SUBJECT: Withdraw of the November 16, 2015 Application for Modification, AND Application for Modification with Additional Information for Section 404 Individual Permit and Section 401 Individual Water Quality Certification for the US-74 Monroe Connector/Bypass in Union and Mecklenburg Counties. STIP R-3329 and STIP R-2559, Division 10, Debit WBS Element 34533.1.TA1 in the amount of \$570.

Reference: US Army Corps of Engineers (USACE) 404 Permit issued May 8, 2015; Action ID: SAW-2009-00876
NC Division of Water Resources (NCDWR) 401 Water Quality Certification Permit issued March 6, 2015; NCDWR Project No. 02-0672 V3

The North Carolina Department of Transportation (NCDOT) is in the process of constructing the Monroe Connector/Bypass, as authorized by the USACE and NCDWR as referenced above. NCDOT is requesting a permit modification for ten Permit Sites: 3, 5, 29, 30, 37, 46, 47, 48, 54, and 57, which are detailed below. Two other sites, 6 and 60, have revisions in jurisdictional areas that do not require a permit modification (see below).

Permit Site 60 (Revised Permit Drawing 239 and 240 of 267):

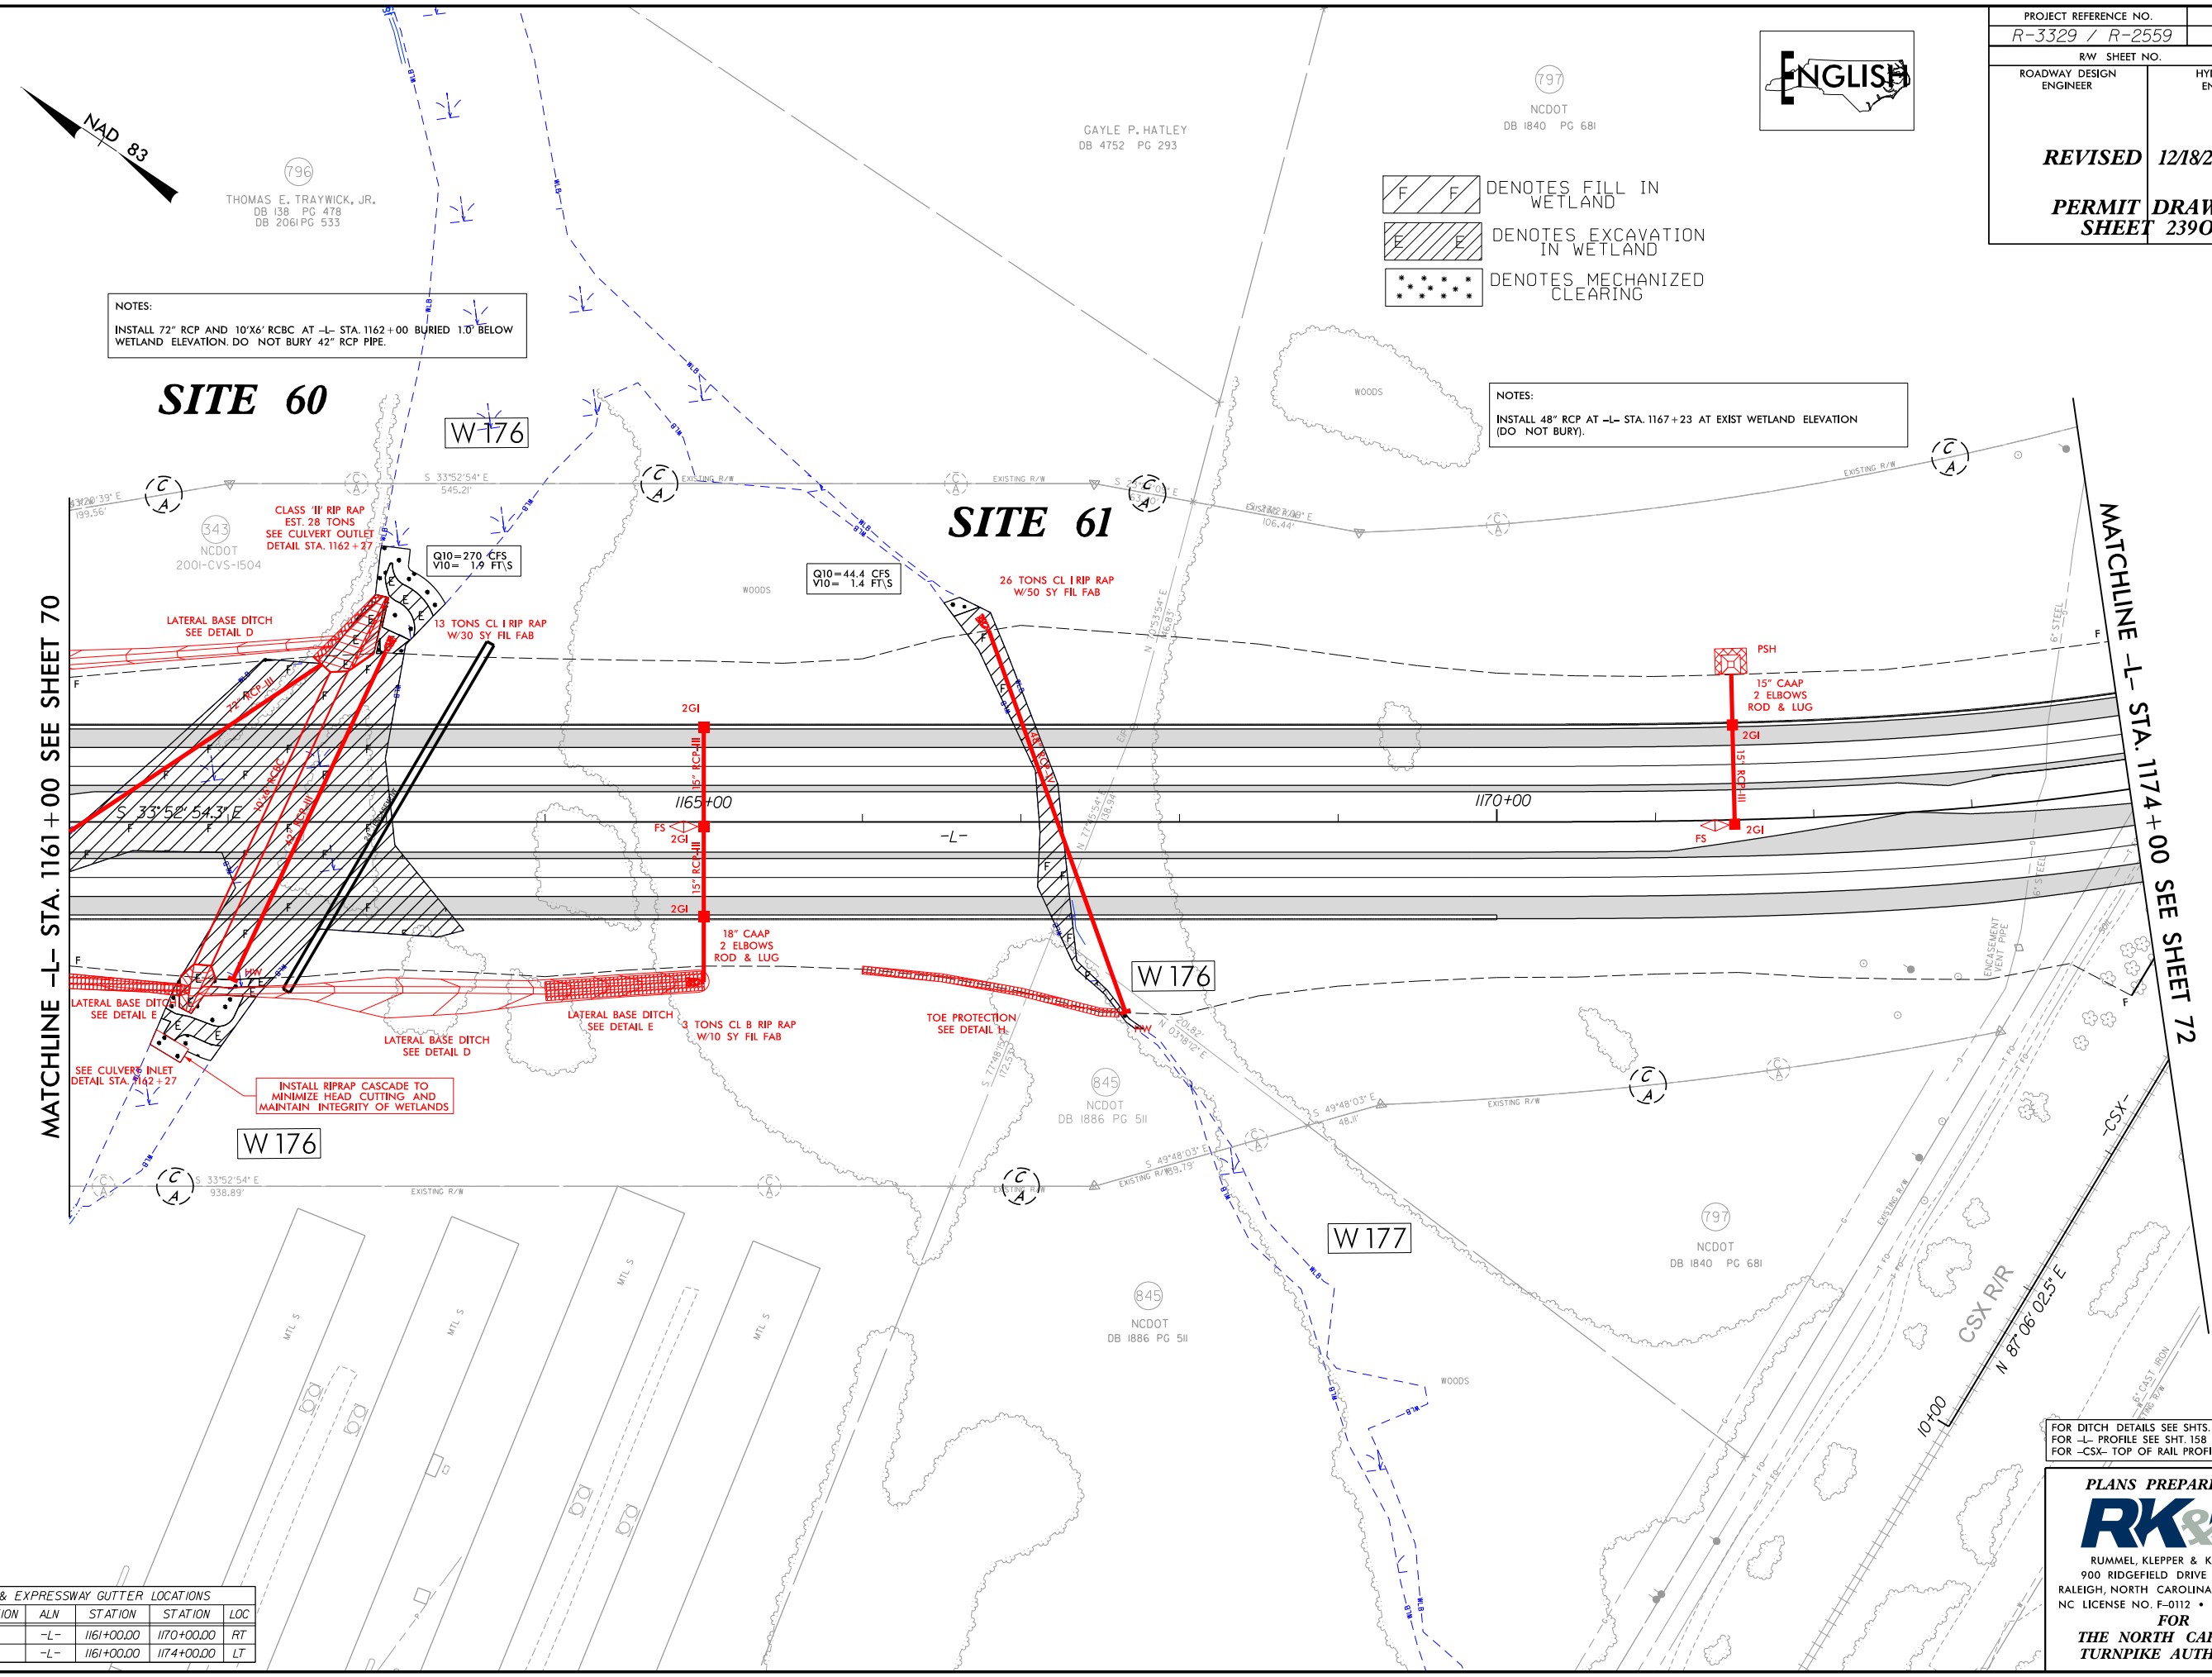
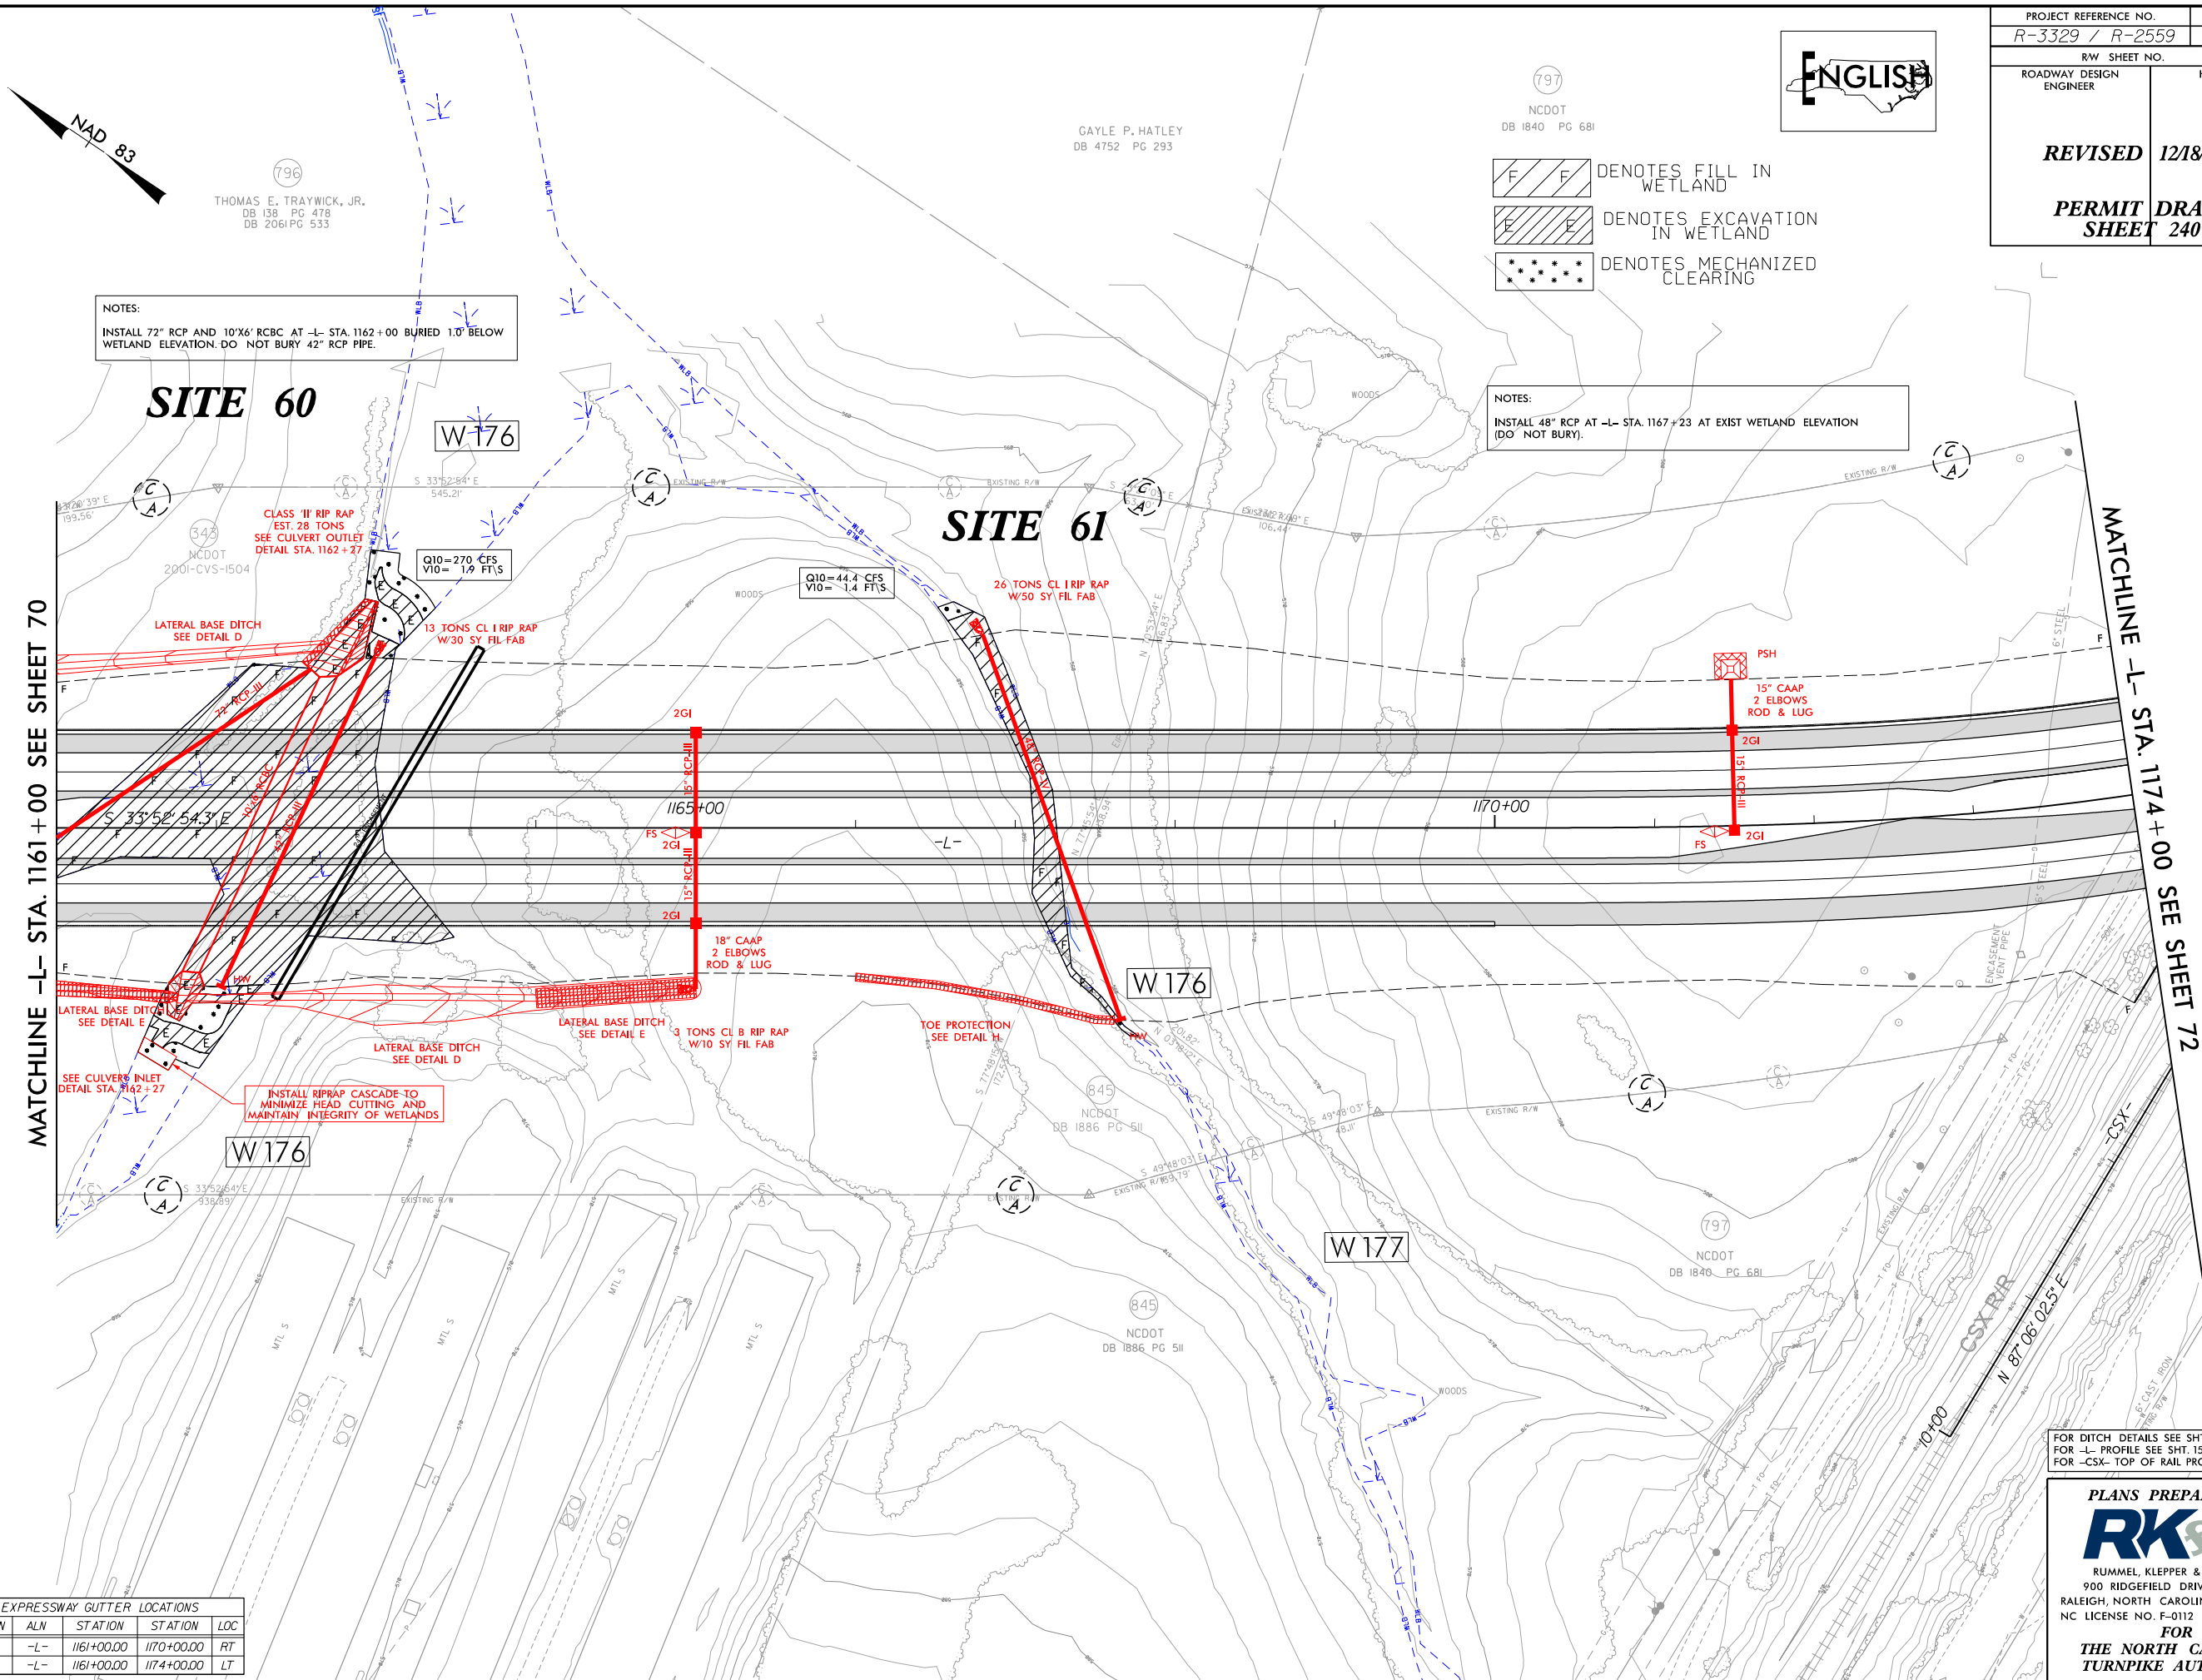
- Permit Site 60: 15 lf of temporary impacts to minimize stream/wetland impacts in already permitted area (no change in impacts)
